GLENELG BROCHS - CAR PARKING

GLENELG BROCHS - CAR PARKING

GLENELG BROCHS - CARPARKING

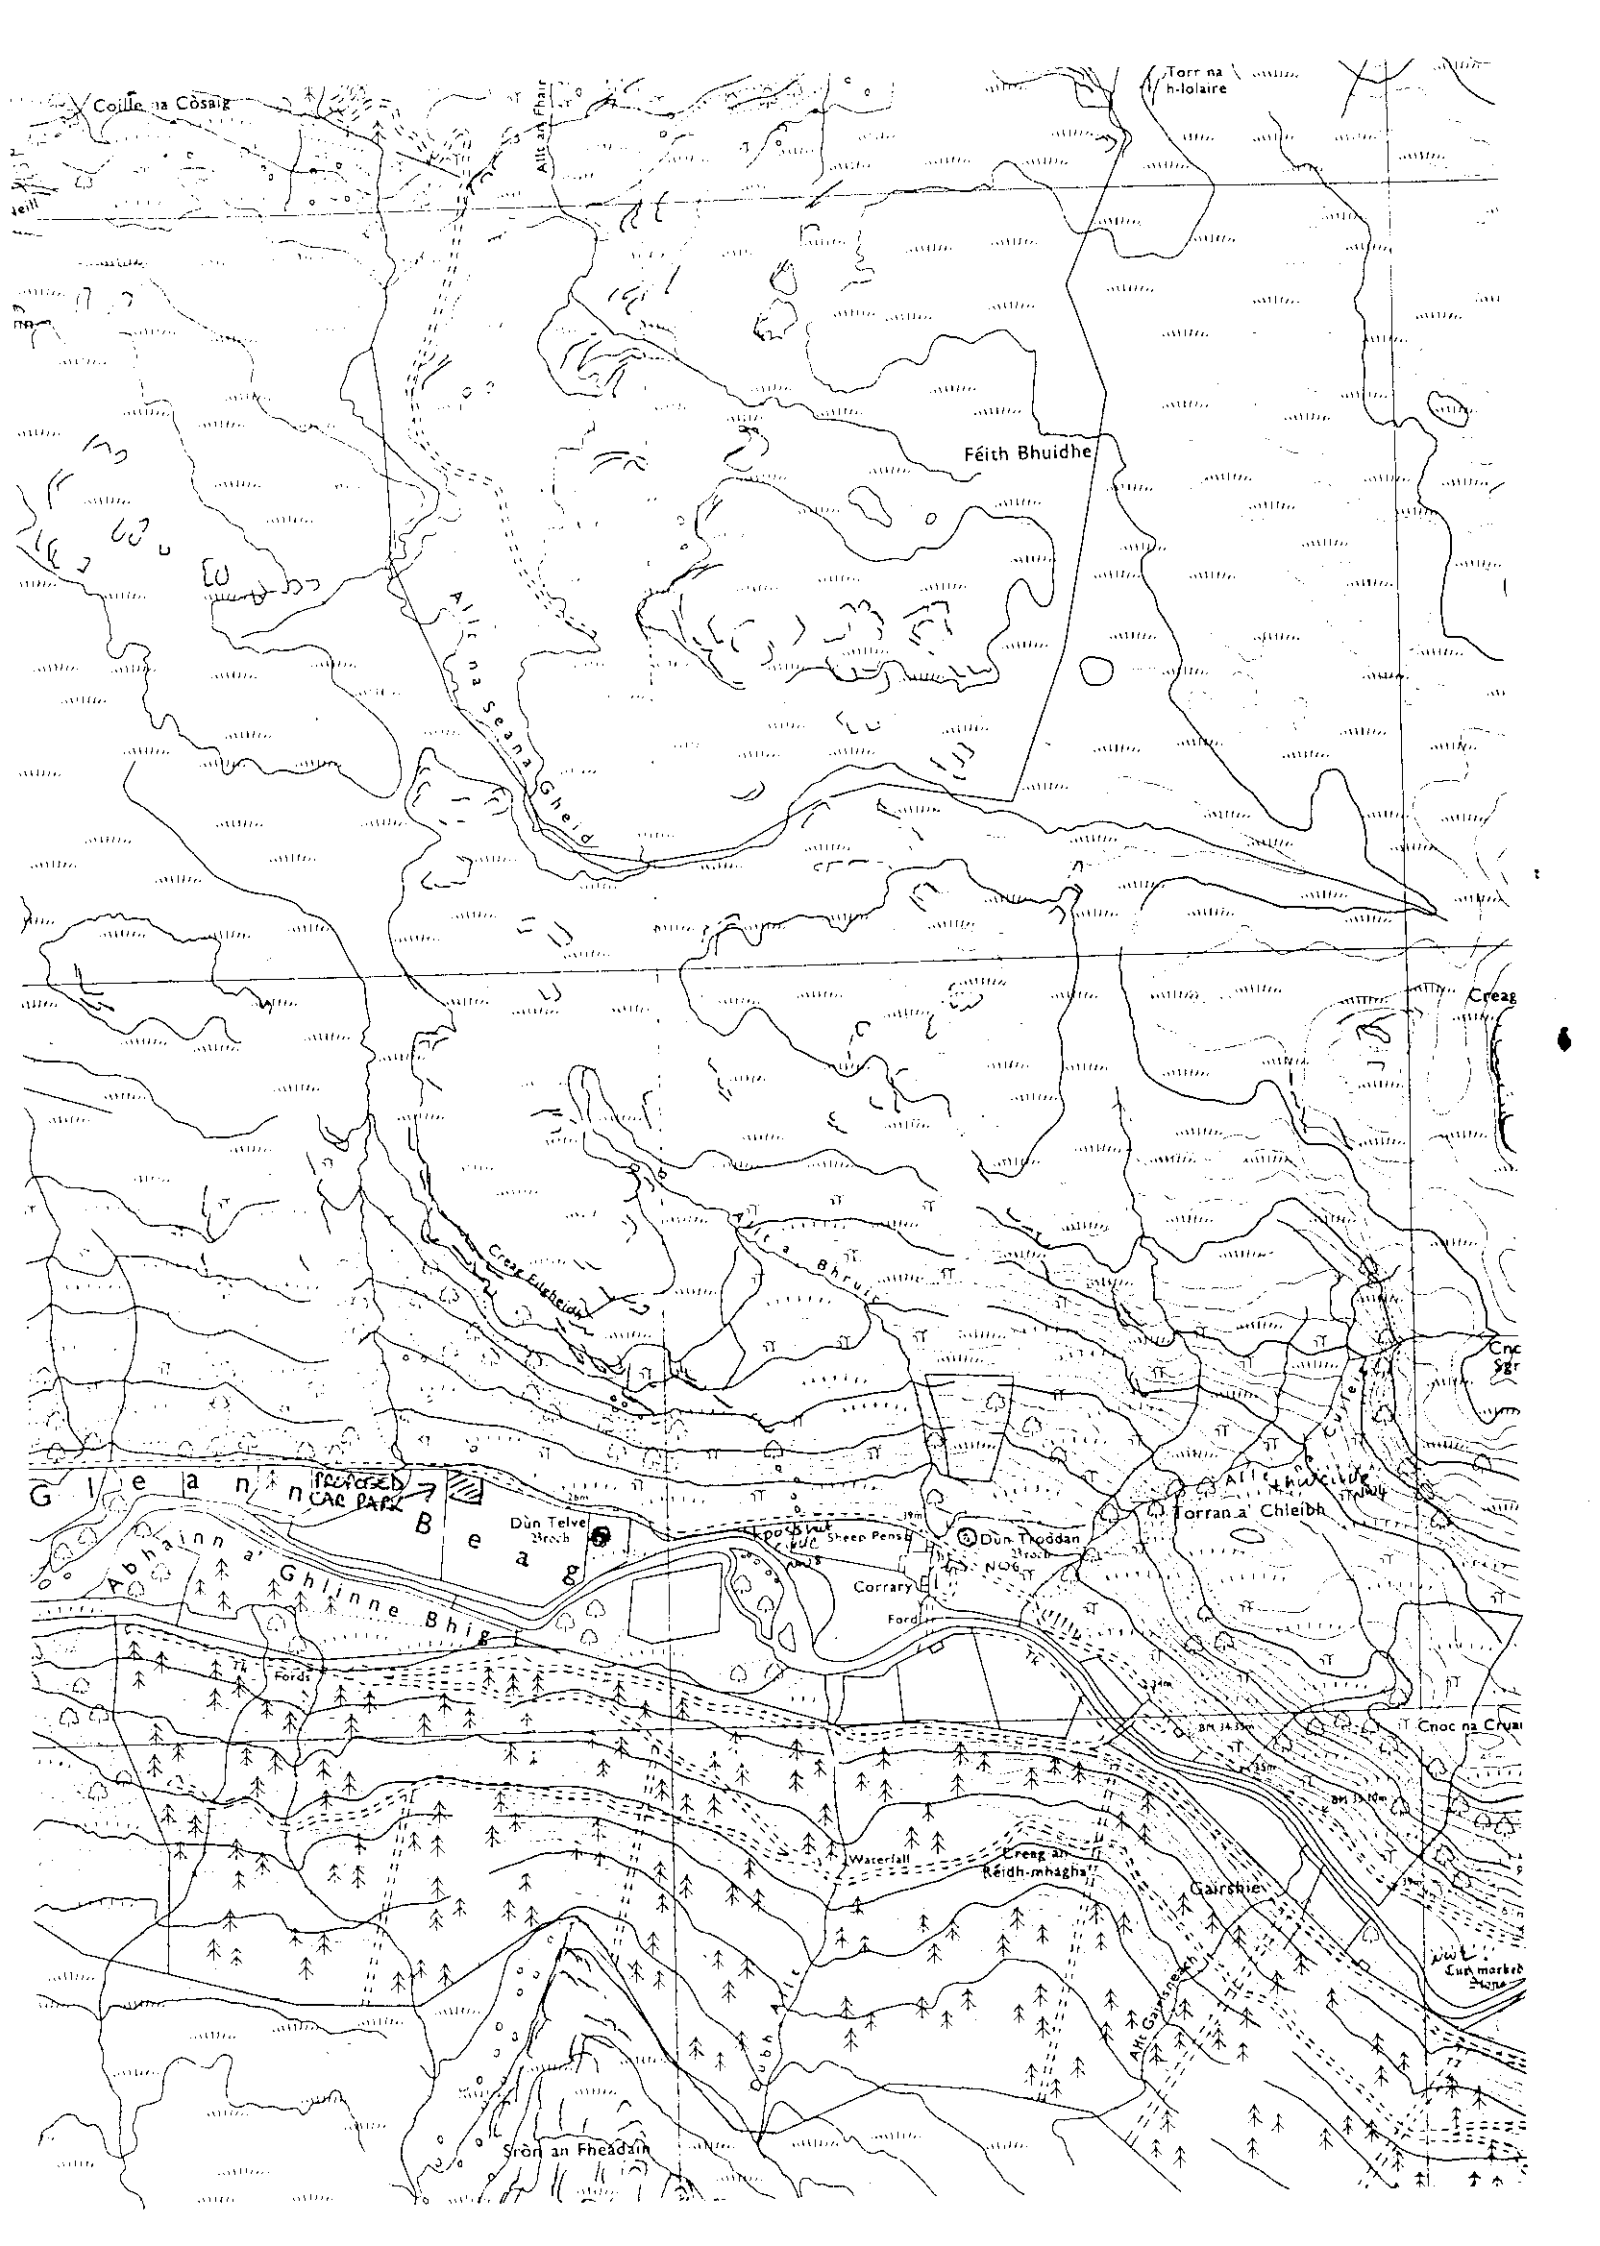
Whilst we welcome the proposed construction of a car park we do not believe the location suggested by the Region is ideal. Construction of a car park in close proximity to Dun Telve would involve the demolition of stone dykes and, we believe, have a detrimental effect on the visual setting of the Broch. Of particular concern to us would be the possibility of archaeological deposits being revealed during the progress of the construction work.

As a possible alternative we have identified an area of ground further to the west of Dun Telve (see attached map) which we feel would have less impact on the setting of the Broch and is far enough away to reduce the likelihood of archaeological features being disturbed. Pedestrian access to the monument could be provided without the need to cross or walk on the public roadway which is single track at this point. We would also be able to take the opportunity to develop this pathway in order to provide access suitable for disabled visitors, which we have been keen to do for some time.

We strongly recommend this location to you and hope you give this your serious consideration. A watching brief during construction, which I suggest should be funded by the Region, would be necessary.

Thank you for your letter. At present, the provision of car parks has been temporarily set aside, but not forgotten. The advice of Historic Scotland with regard to the actual location will be taken into account, and I would think that the location suggested - the W end of the field approaching Dun Telve - is likely to be selected. However, we will keep you informed as and when this project is taken up. Please let me know if you wish any further information.

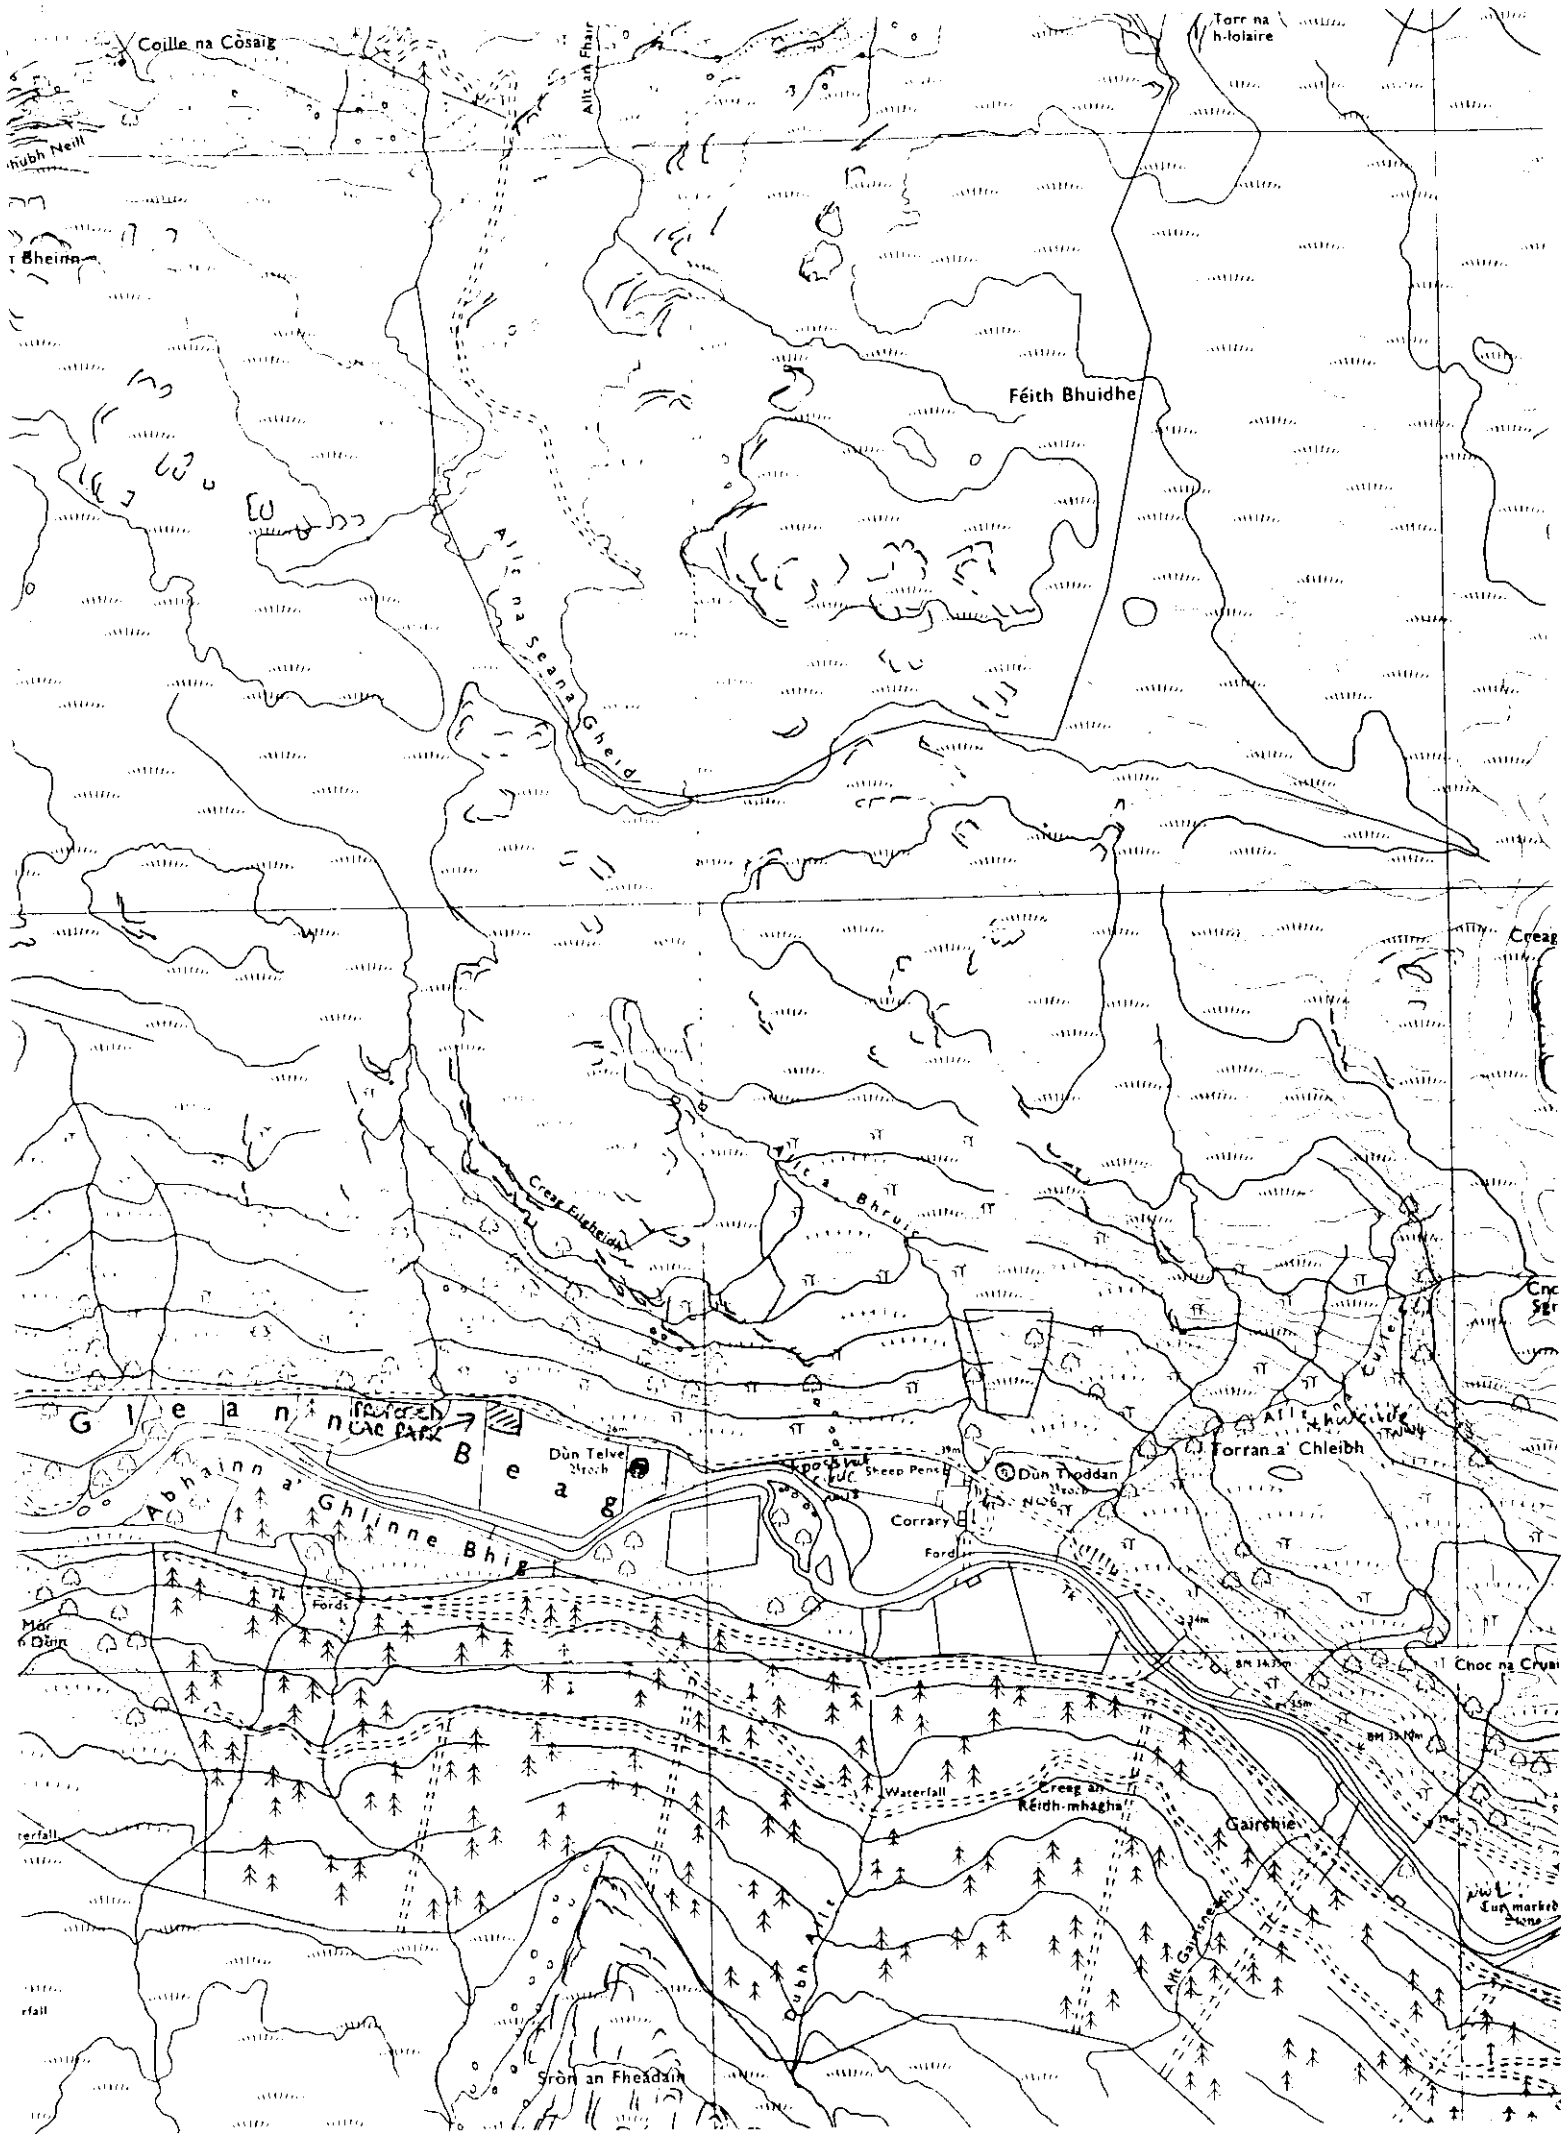
Whilst we welcome the proposed construction of a car park we do not believe the location suggested by the Region is ideal. Construction of a car park in close proximity to Dun Telve would involve the demolition of stone dykes and, we believe, have a detrimental effect on the visual setting of the Broch. Of particular concern to us would be the possibility of archaeological deposits being revealed during the progress of the construction work.

As a possible alternative we have identified an area of ground further to the west of Dun Telve (see attached map) which we feel would have less impact on the setting of the Broch and is far enough away to reduce the likelihood of archaeological features being disturbed. Pedestrian access to the monument could be provided without the need to cross or walk on the public roadway which is single track at this point. We would also be able to take the opportunity to develop this pathway in order to provide access suitable for disabled visitors, which we have been keen to do for some time.

We strongly recommend this location to you and hope you give this your serious consideration. A watching brief during construction, which I suggest should be funded by the Region, would be necessary.

Thank you for your letter. At present, the provision of car parks has been temporarily set aside, but not forgotten. The advice of Historic Scotland with regard to the actual location will be taken into account, and I would think that the location suggested - the W end of the field approaching Dun Telve - is likely to be selected. However, we will keep you informed as and when this project is taken up. Please let me know if you wish any further information.
